TRANSPORT STATEMENT

Ravenshouse Road, Dewsbury

**Consultation Response from KC,
Highways Development Management**

**2023/91715 Mohaddis E Azam Education Centre And Masjid E Madani, 225C, Ravenshouse
Road, Dewsbury Moor, Dewsbury, WF13 3QU**

DWG
No: AIB / 01

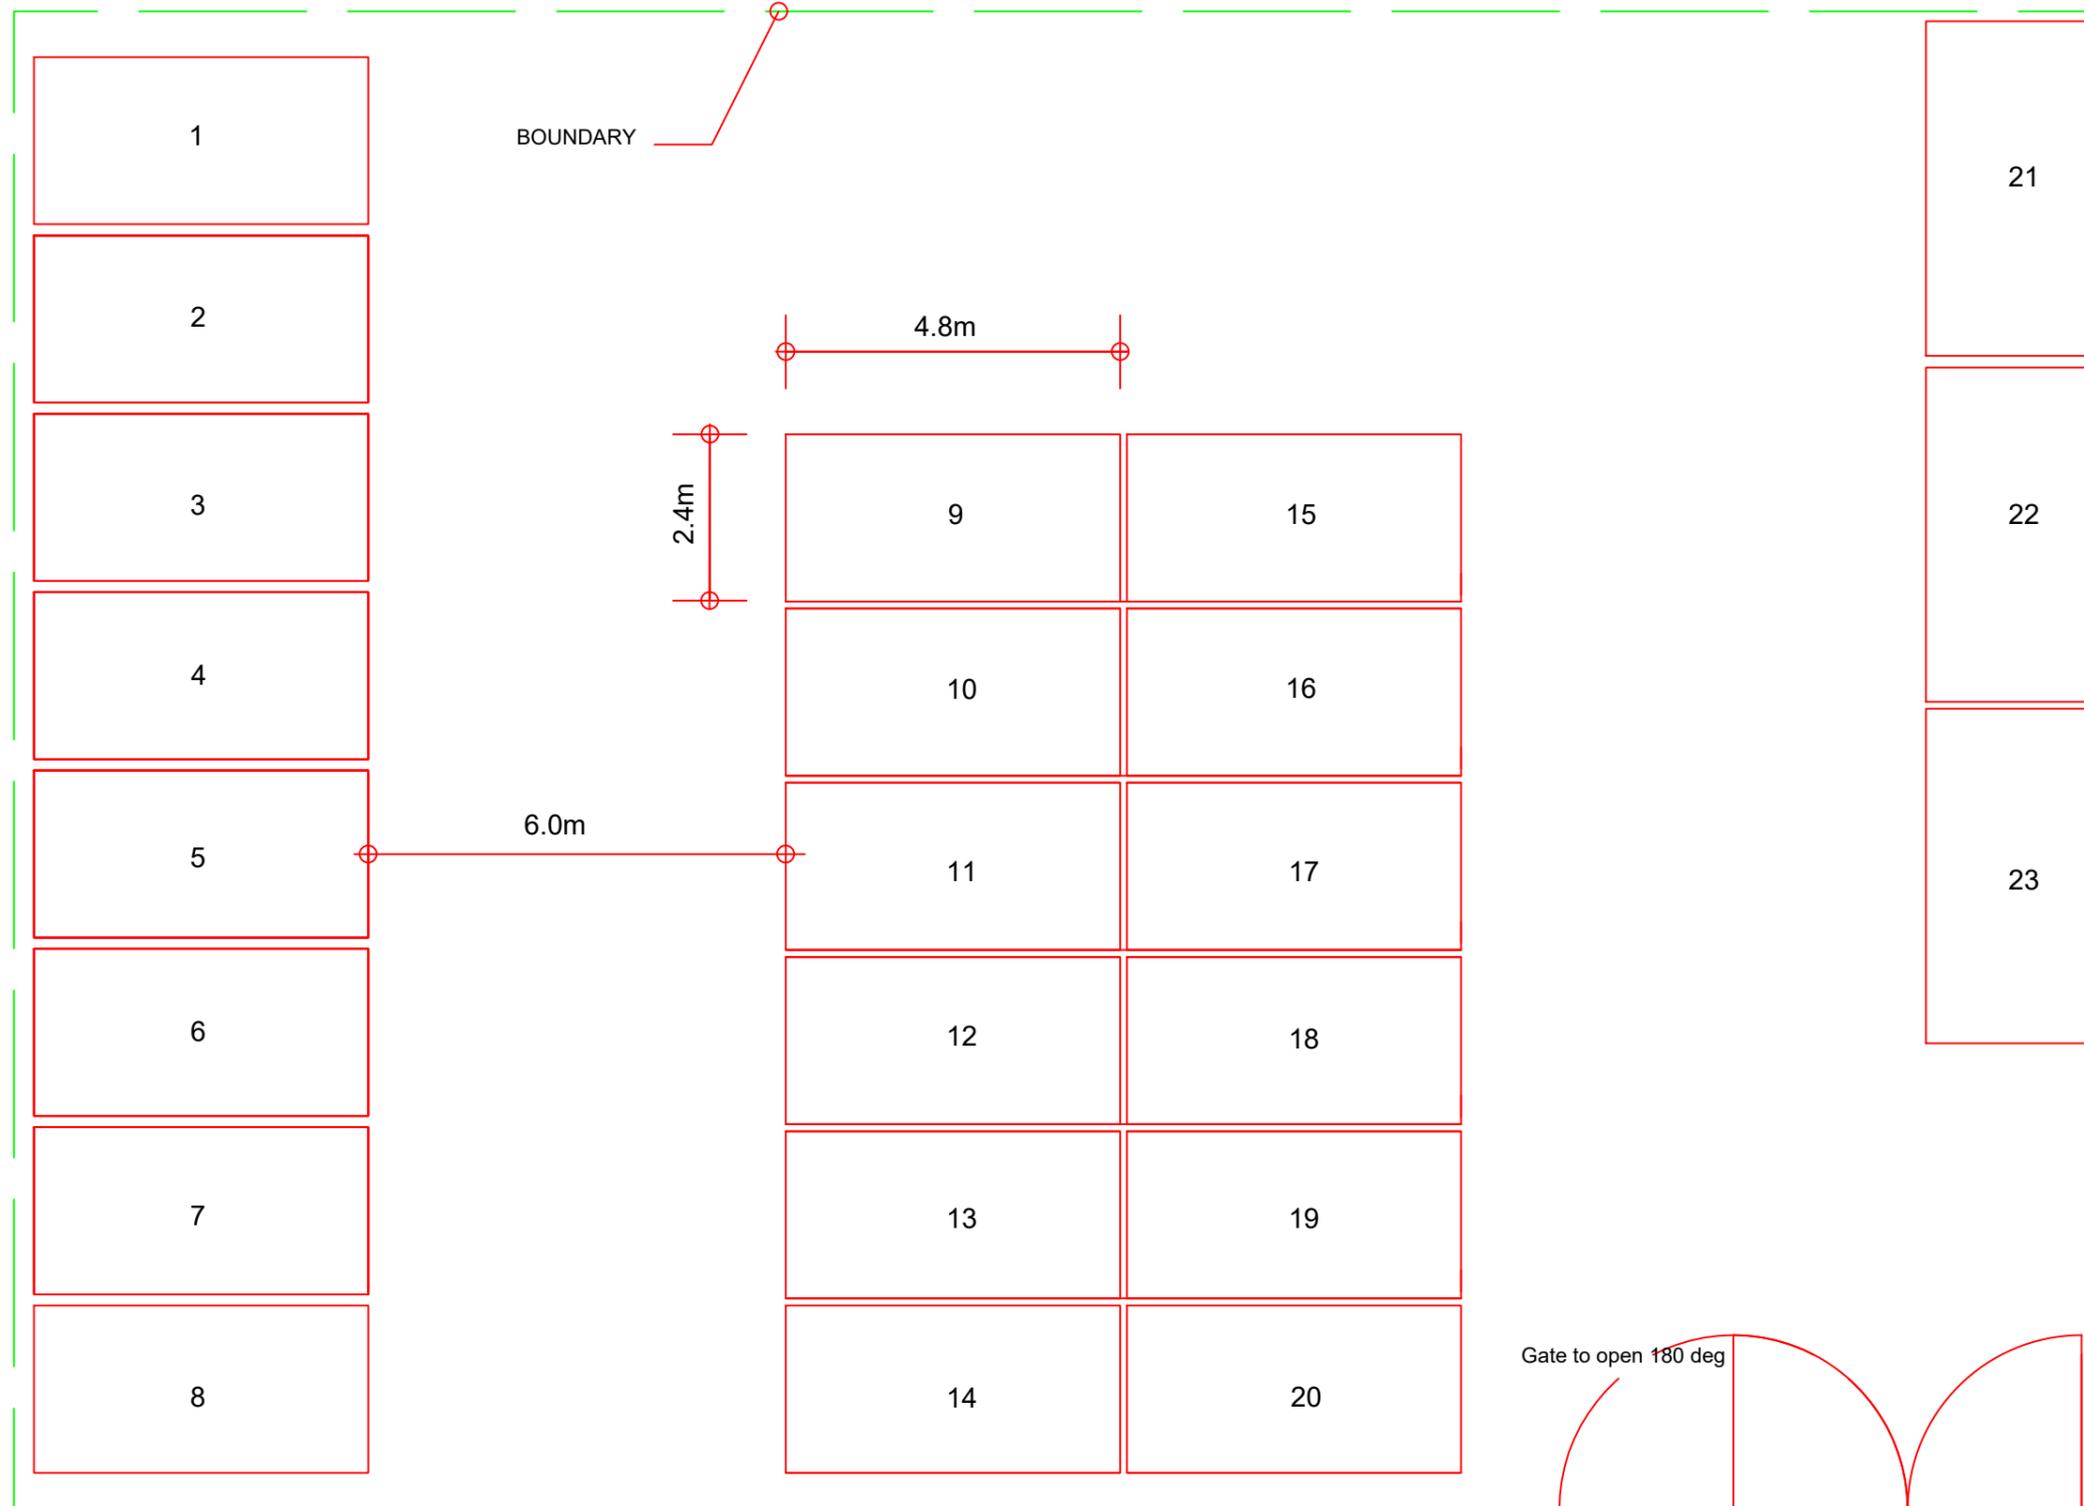
The proposed car park is set out in drawing No AIB/01 Proposed Layout (Sept 2021) and shows a single access with 23 parking spaces, however paragraph 4.6 of the submitted planning statement suggests that there are spaces for 26 cars with two disabled spaces and this is not what is shown on the parking layout drawing. The parking spaces scale to approximately 2.4m x 4.8m with a 6m headway between spaces 1 to 20 to allow cars to manoeuvre safely. Spaces 21 to 23 are tandem against the edge of the car park and don't allow for independent access, ie space 23 would block in the other two spaces and space 22 would block in space 21. This may be suitable for staff parking or use at prayer times if the car park is managed and attendants can stack the cars, this process has been observed in use at other similar land uses, but this would require the use of marshals to control the parking.

Drawing No AIB/01 Proposed Layout (Sept 2021) shows the car park with a single access over a dropped kerb crossing. The site, as constructed, has two gates and two dropped kerb crossings on to Ravenshouse Road and a single vehicle and separate pedestrian access on to the Back Ravenshouse Road. To comply with the proposal drawing we would like to see the second gated access on Ravenshouse Road (to the south) removed and the redundant dropped kerb crossing reinstated to a full kerb with the "H-bar" marking removed, and the vehicular access on to Back Ravenshouse Road removing. These changes should be clearly marked on a drawing and should be conditioned for highway safety reasons if you are minded for approval, and the works done within a s184 legal agreement with the council, with an appropriate footnote included, wording can be provided if required.
